DEVELOPMENT SERVICES ENGINEERING PLANS REVIEW

LEGAL ADDRESS: 1501 Alton Road

PLAN DESCRIPTION: Financial Institution (Savings of America)

Grading Plan

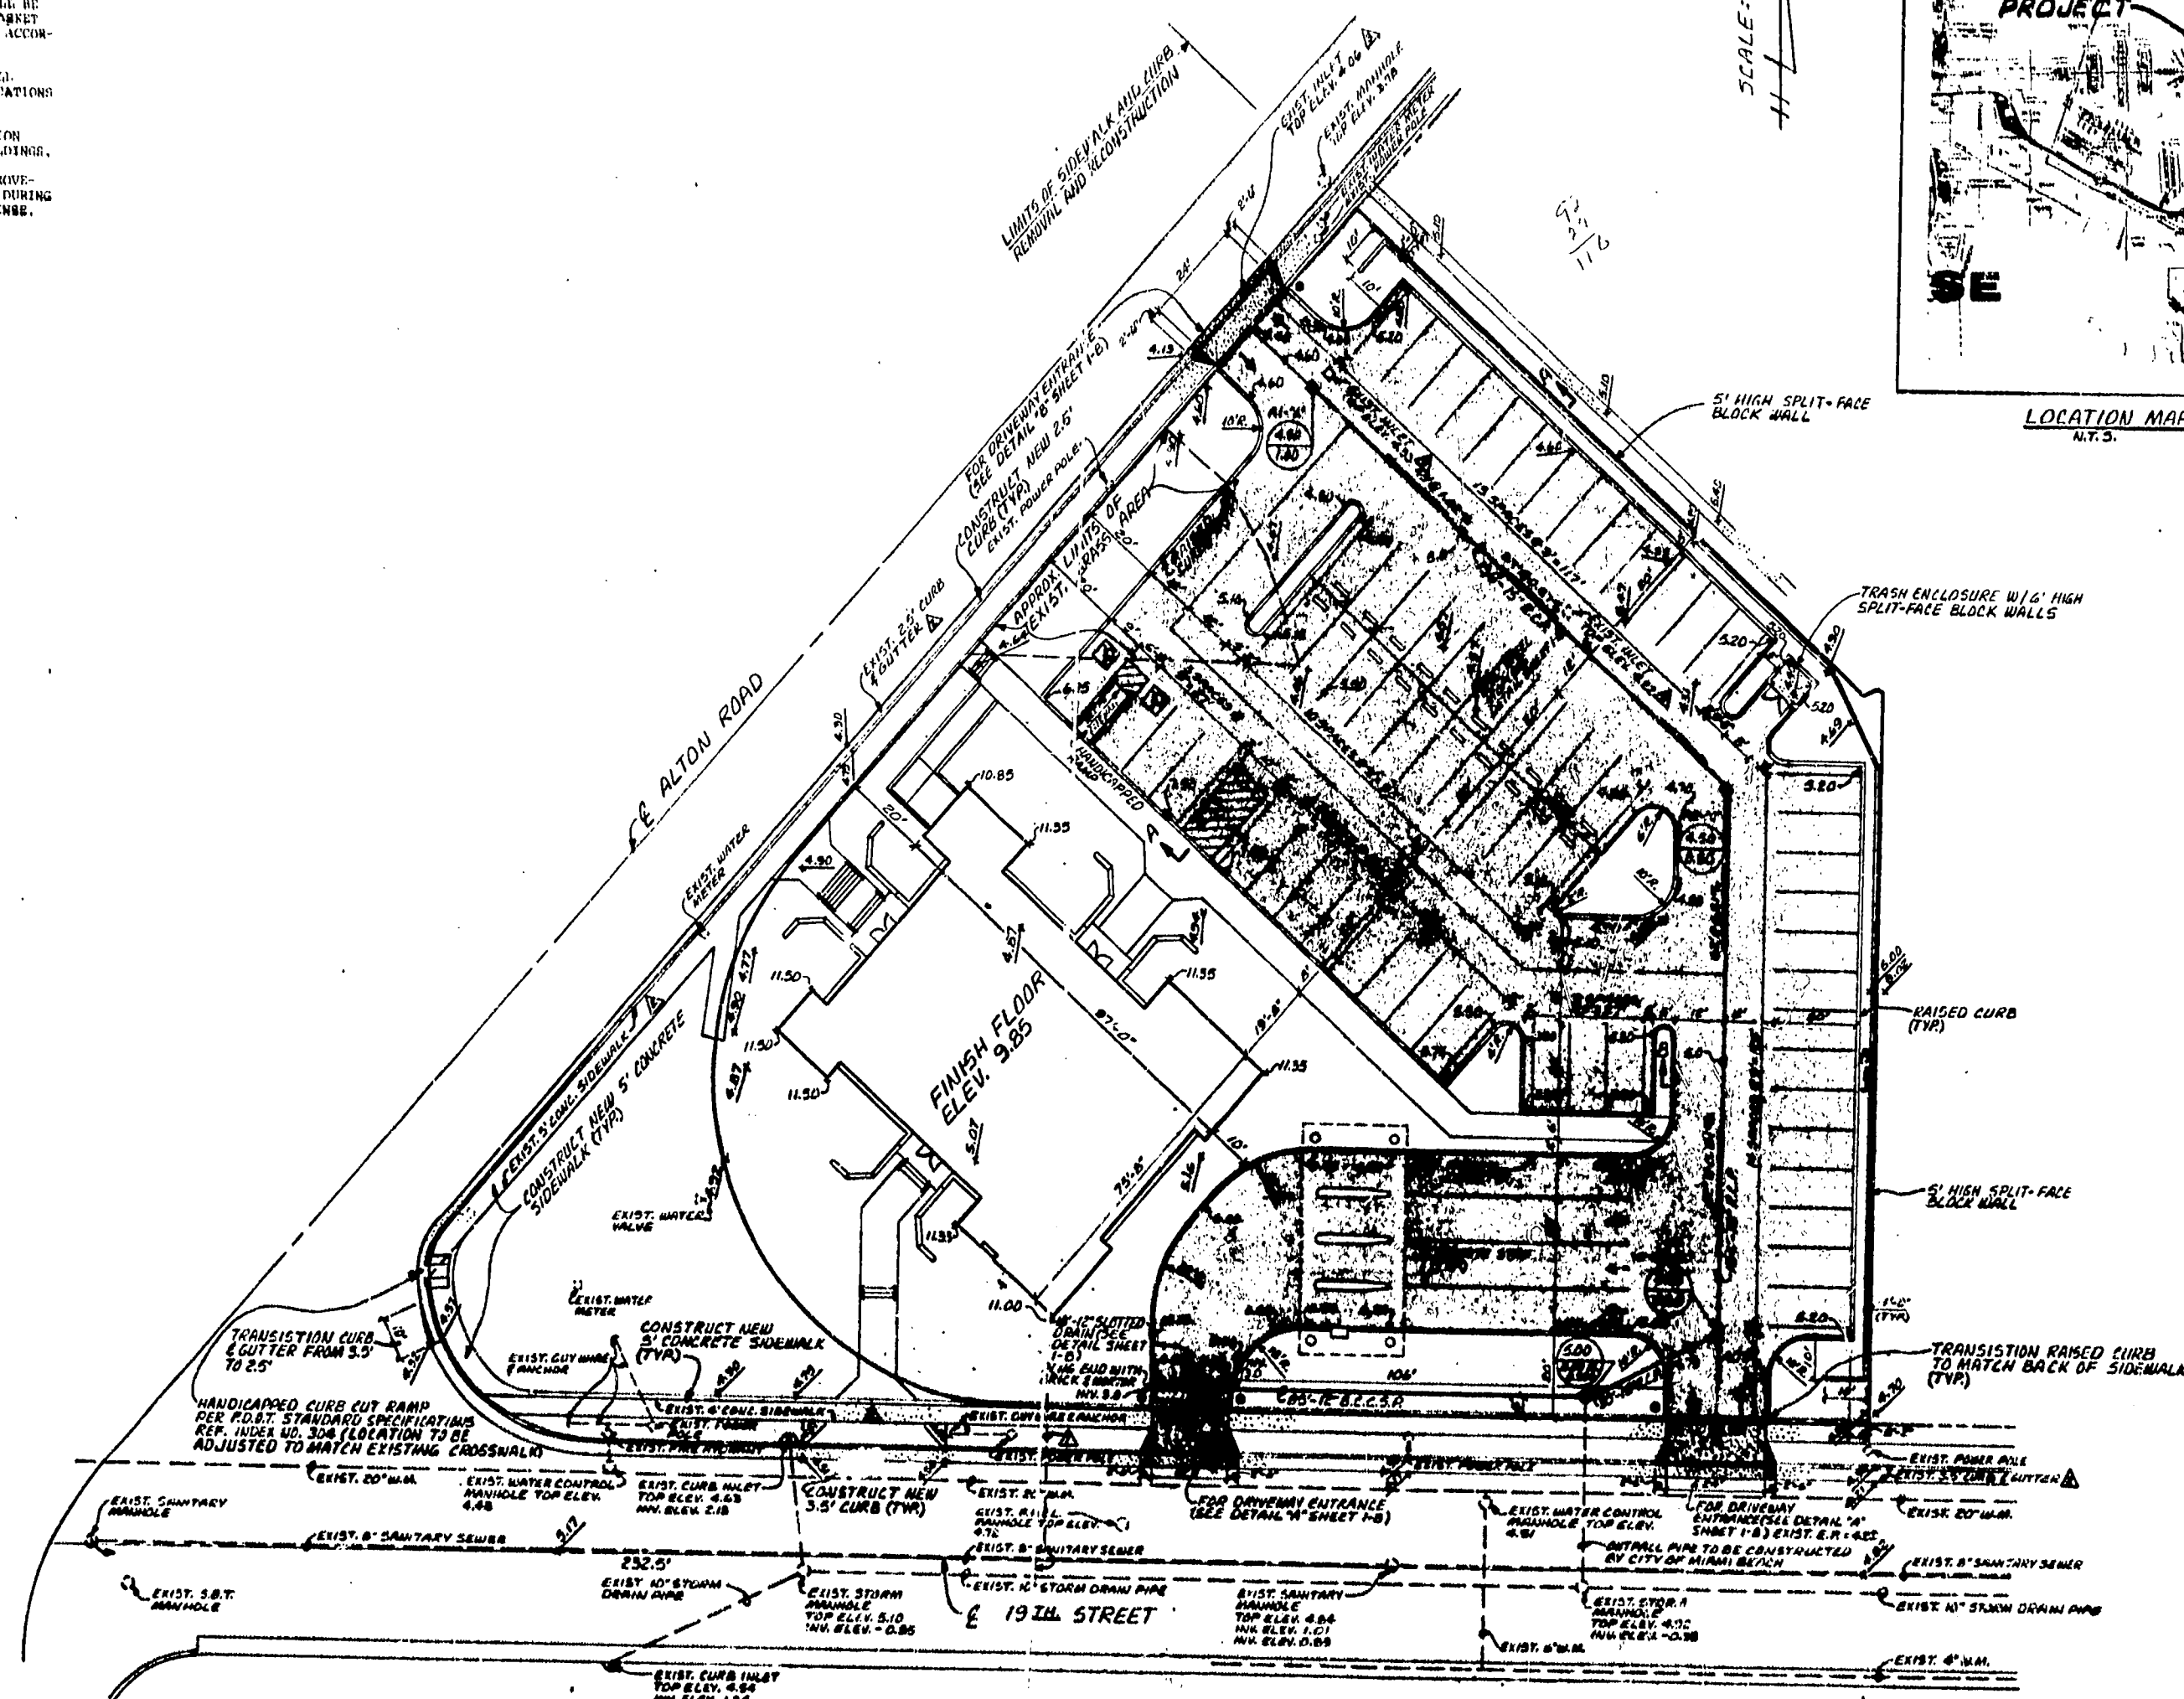
DRAINAGE: See Note #2
Silt yards to be sloped so as to not shed water to neighboring properties. A/C condensate to be piped to sewer drainage well to be located on private property.

GRADES: To meet Federal Flood Insurance criteria of +9.00 MSL (+9.85 U.S.L.D., Bay Datum)

Note #2 - Public Works Dept. to estimate cost for extending storm pipe from manhole to property line.
